**DEPARTMENT OF PLANNING AND  
COMMUNITY DEVELOPMENT**

**Subject: Conditional Use Permit Case No. 06-CUP-007 and Sign Permit Case No. 06-SP-037 (Danari Oak Creek, LLC)**

**Date: February 21, 2008**

DATE: MARCH 14, 2007  
 DRAWN BY: DAVID W. HALL  
 CHECKED BY: ADLER REALTY  
**PRELIMINARY LANDSCAPE PLAN**  
**WEST PARCEL**  
 PARCEL: 2971  
 SHEET: L-1

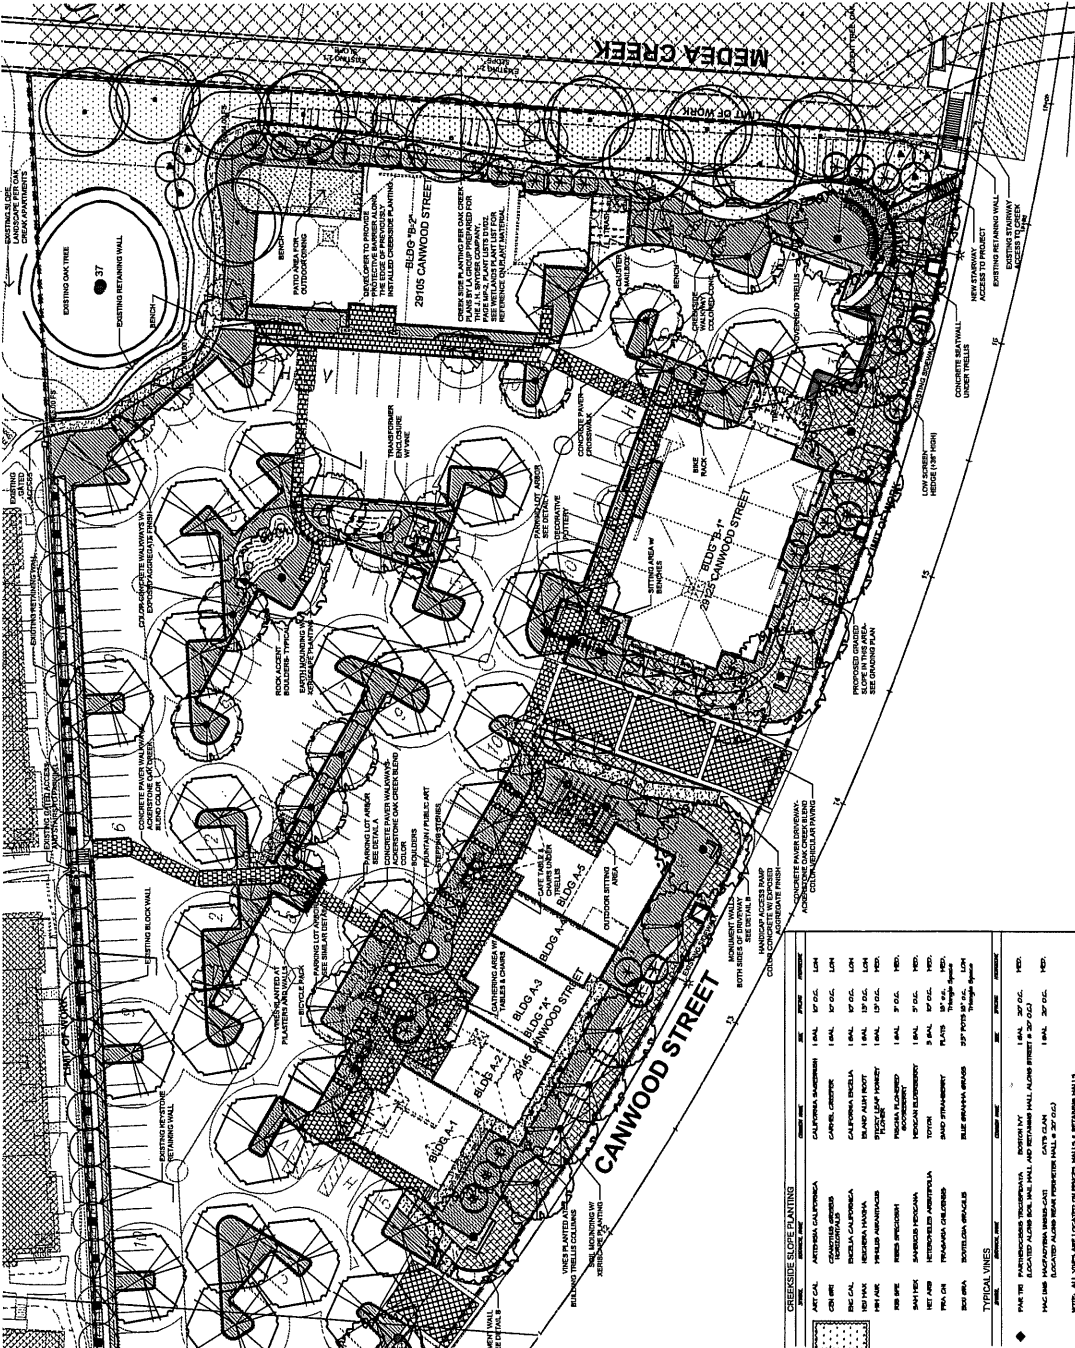
- The creek should be better utilized in the project design.
- Provide a strong pedestrian connection between the properties on the east and west sides of Medea Creek. Consider providing a pedestrian bridge over the creek to accomplish this connection.
- Provide a wider landscape buffer along the creek.
- Add more landscaping within the project, including the provision of more Sycamore and Oak trees.
- Provide more decorative paving within the project.
- Provide a pedestrian connection from the northwest corner of the parking lot to the adjacent sidewalk on Canwood Street.
- Center the footprint of Building B-1.
- The footprint of Building A appears too linear and should be modified to reduce its visual mass.
- Eliminate the parking spaces adjacent to the creek.
- Consider providing subterranean parking for the project to allow for more restaurant uses.

5. Nine (9) parking stalls were removed from the northwest corner of project, west of Medea Creek. Four (4) parking stalls were moved an additional 18 feet from the creek. This allows for a landscape area of 33 feet to 44 feet in depth. This landscape area was previously proposed with a depth of approximately 12 feet. More benches were added to the pedestrian path along the creek.

6. The trash enclosure serving Building B-2 has been moved away from the creek, allowing for more landscaping between the enclosure and the creek walk.

9. The Landscape Plan calculation has been modified to meet the parking lot tree shade requirements.
10. A new parking lot light fixture has been selected that is intended to be more in keeping with the building design (reference colored fixture specifications within the revised Lighting Fixture Schedule). The lighting plans and calculations have been revised to match the new west side of the parking lot design as well.

# COLOR SCHEME BLDG A

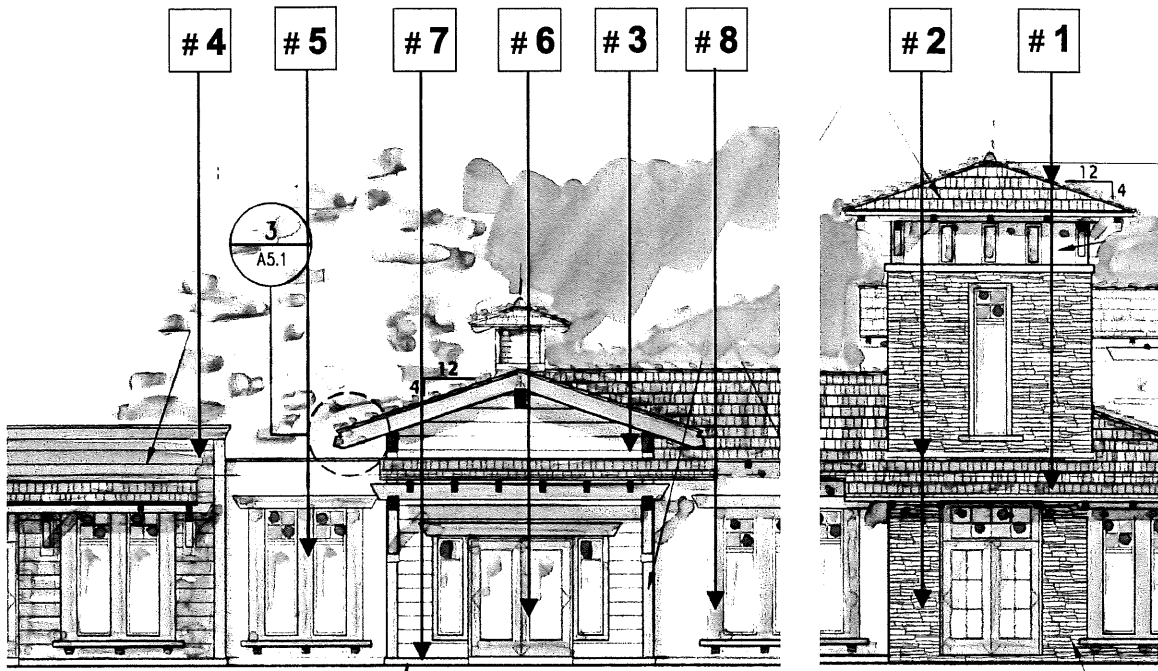
- Modify the design of Building A to reduce its linear appearance.
- Reconsider the orientation of Buildings A and B-1 to reduce their massive appearance as viewed from Canwood Street.
- Provide an alternate parking lot fixture that is more in keeping with the building architecture. The light fixtures should include LED illumination and be shielded.

7. The building elevations and roof plan for Building A have been changed due to the proposed modifications on the building's footprint.
8. The trellis elements on the north side of Building A have been redesigned to allow trees to be interspersed with the trellises in the newly deepened patio area.
